Application of LMPSF Acquisitions, LLC c/o Troutman Pepper Locke, LLP to rezone property from C-2 (General Commercial) zoning district to HR-1 (High Density Residential – 1) zoning district to allow for single-family, attached and multi-family developments, at 3265 Northeast Expressway.

PETITION NO: D2-2025-0628 Z-25-1247529

Site Plan Review (*Illustrative Site Plan - Everstead at Embry Hills, dated 10/17/25*):

OVERALL SITE PLAN

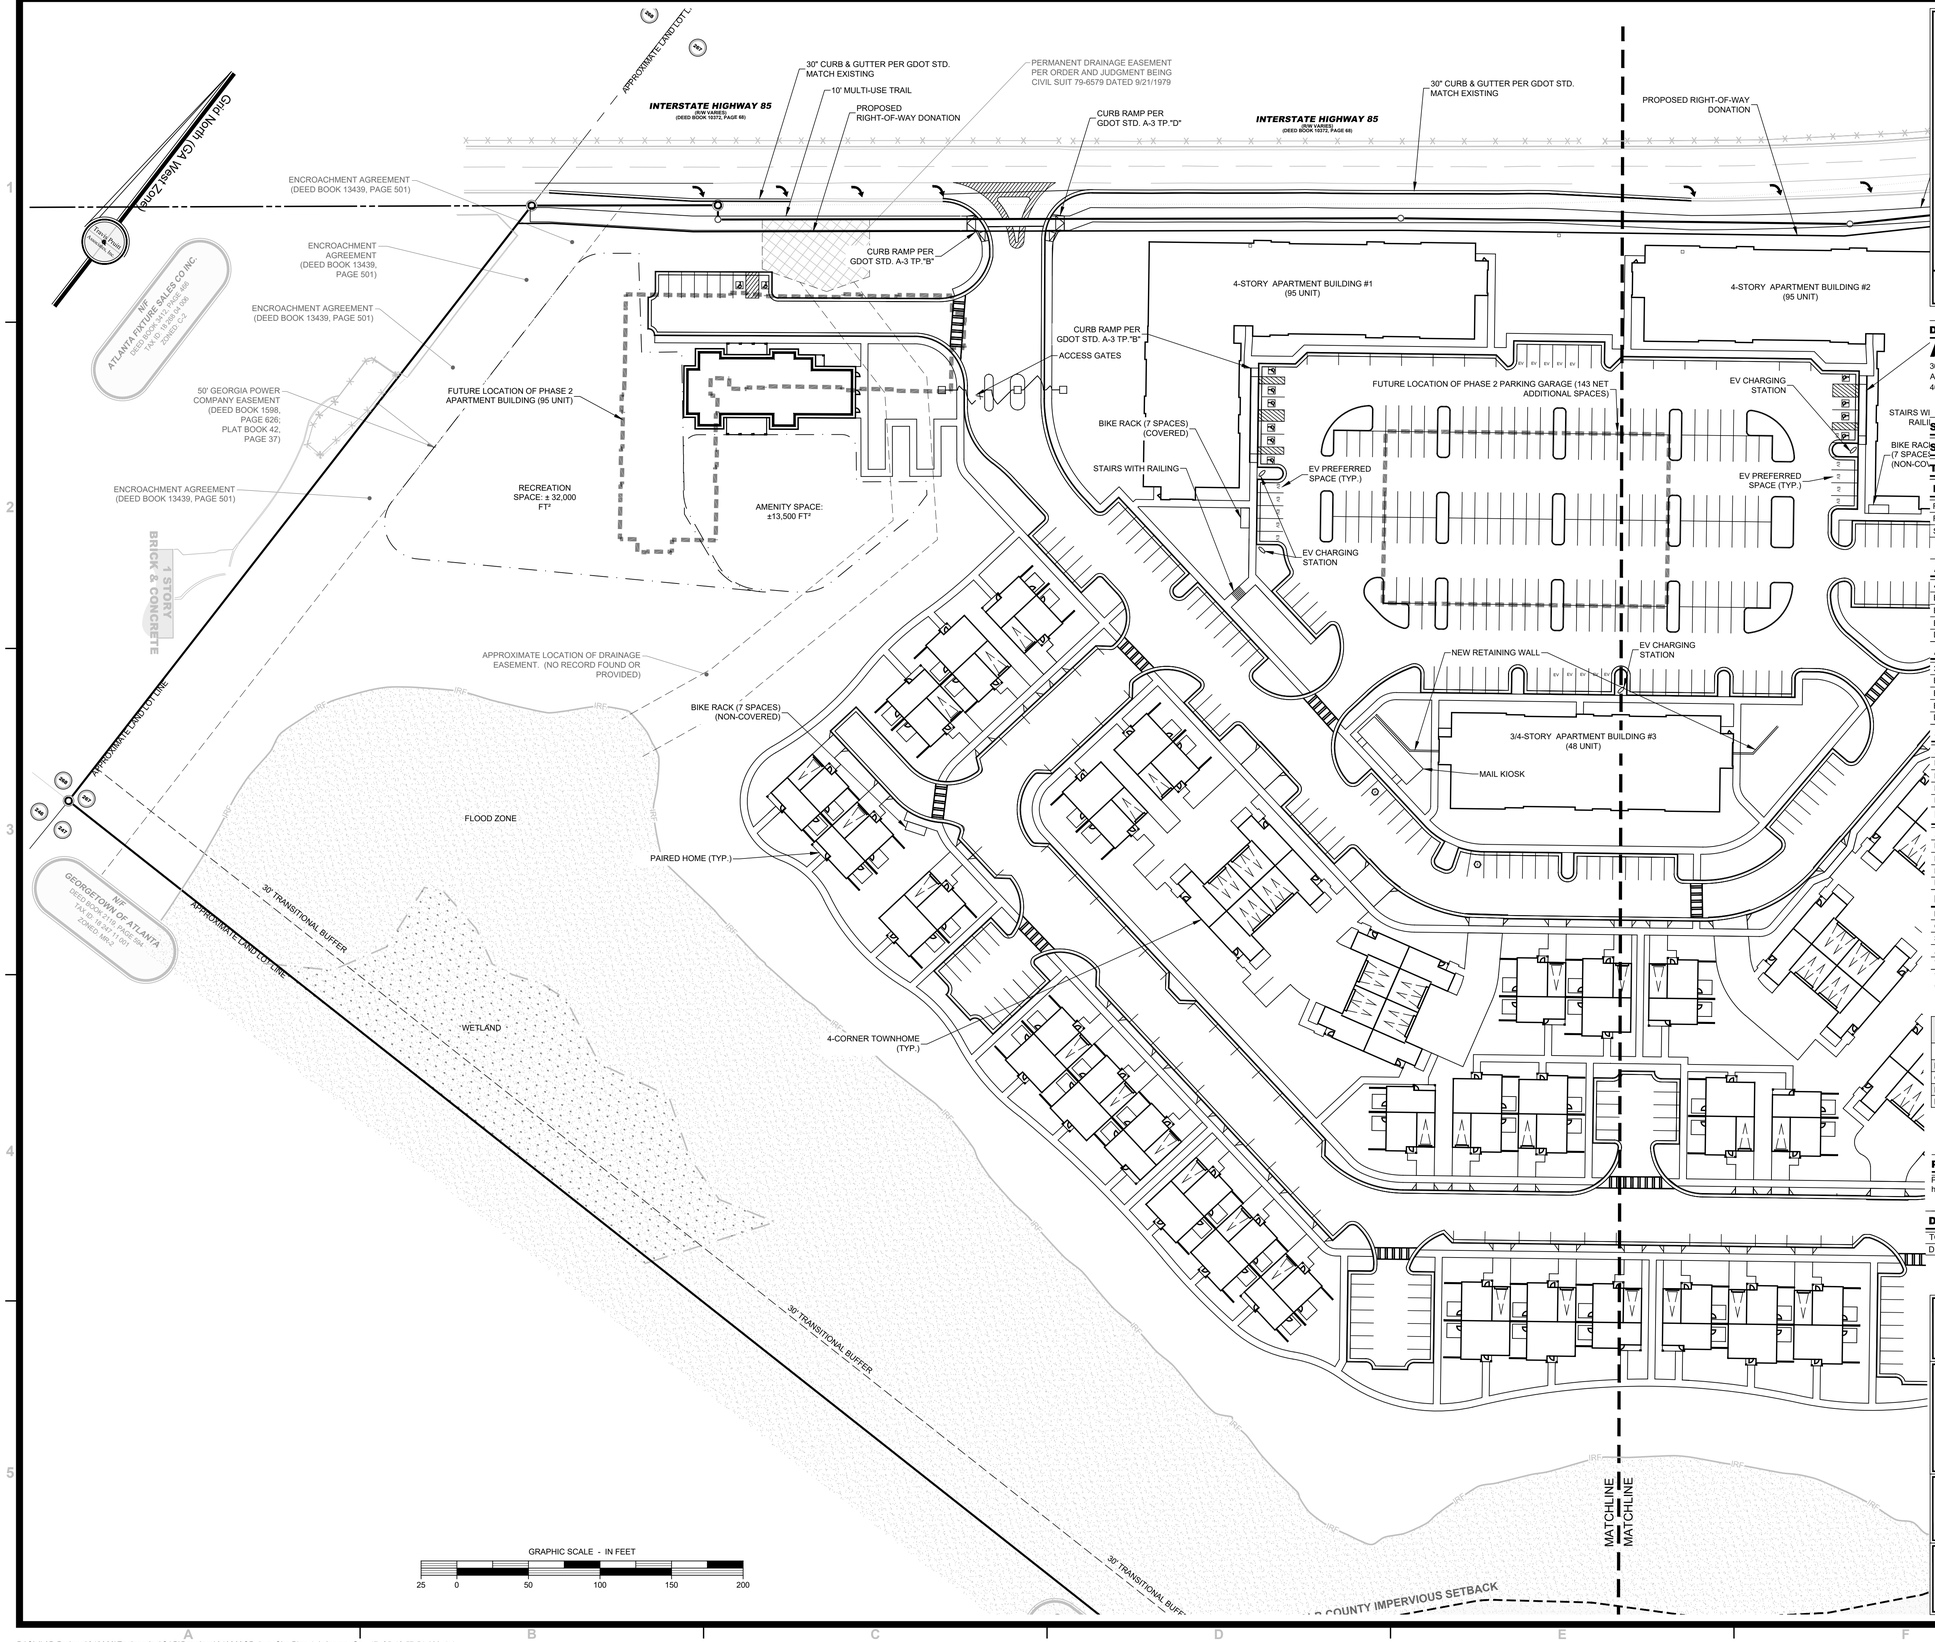
The site plan appears to comply with most of Section *27-2.11.2 – Dimensional Requirements* for HR-1. However, because of the following deficiencies, variances may need to be sought:

- **Interior strips:** Interior to non-residential, mixed-use and multi-family developments, a three-foot (3) wide planted landscape strips shall be required along all interior drives and pedestrian paths per *Section 5.4.4 - Site and Parking Area Landscaping B.* As well as *D. Parking Area Landscaping* tree *and island quantity (4 and 5).*
